CITY PLAN COMMISSION REPORT

Project Name Crescendo

Docket # Request
11 CD-CPC-2021-00182
Rezoning to UR

Plan Conditions, Corrections, & Recommendations Report

1 SITE PHOTOMETRIC LIGHTING CALCULATIONS PLAN
 SCALE: 1"=30'

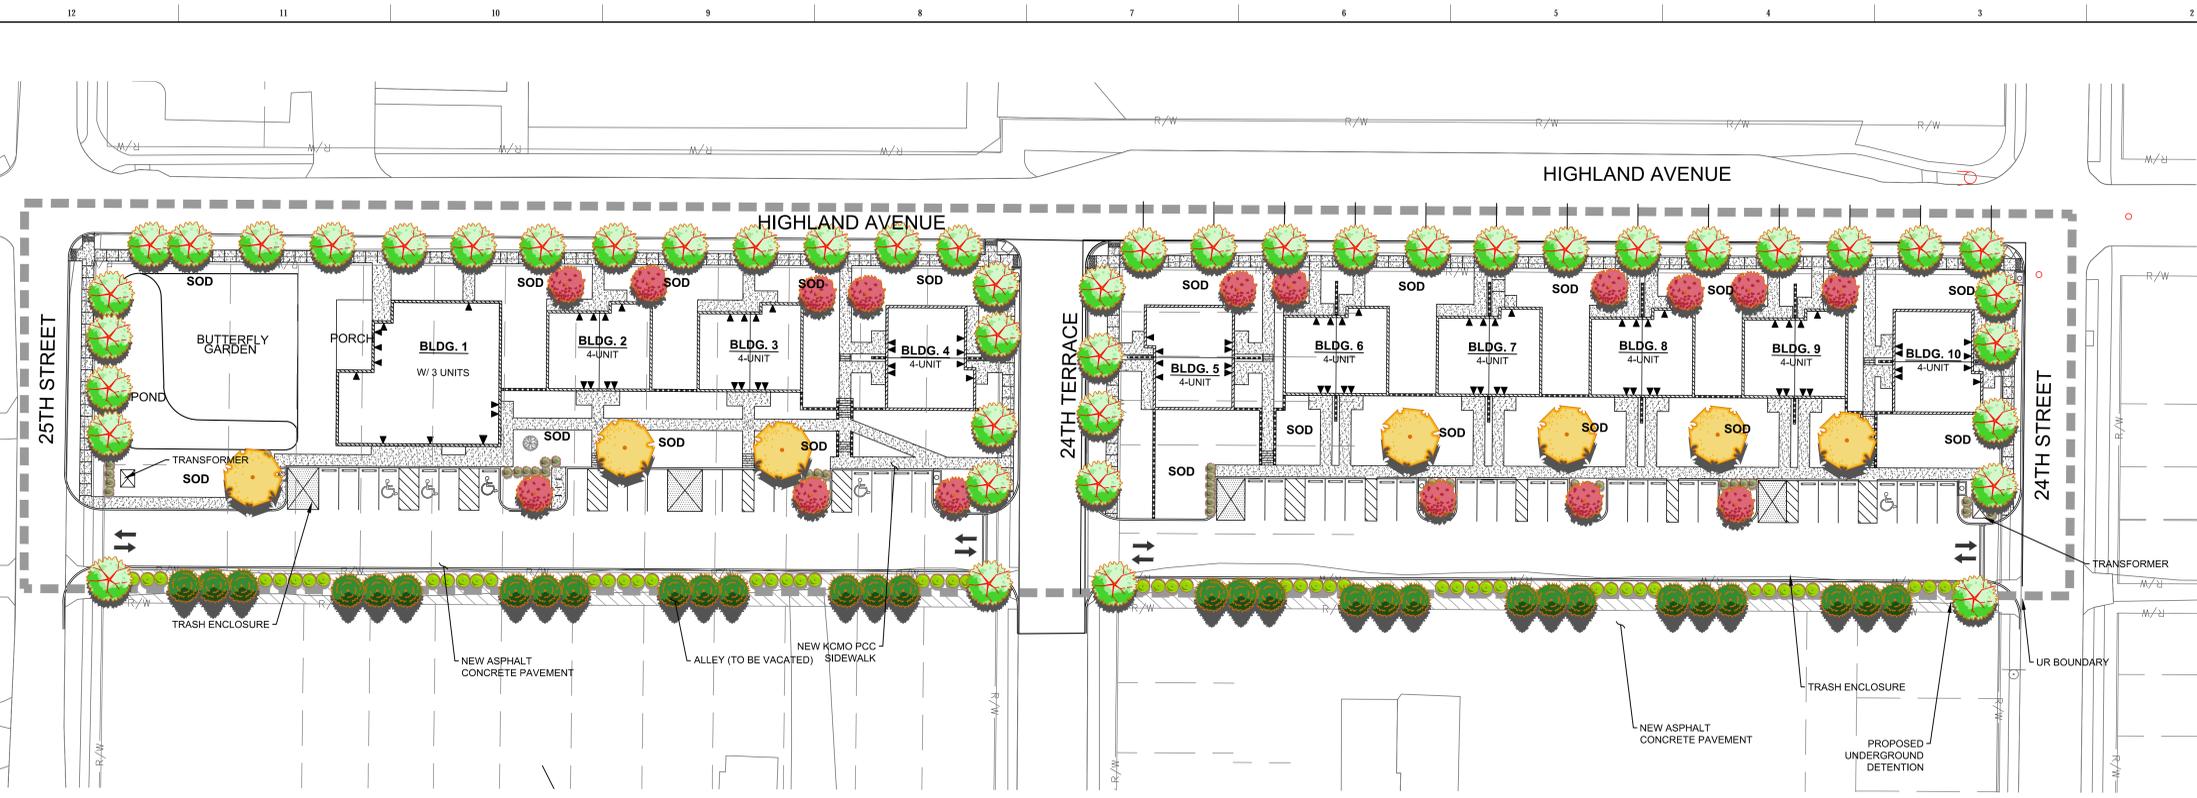
The proposed outdoor lighting spills over into the public right-of-way and adjacent residential properties. One condition of approval for this project is to submit revised lighting plans to meet 88-430-04-C prior to building permit.
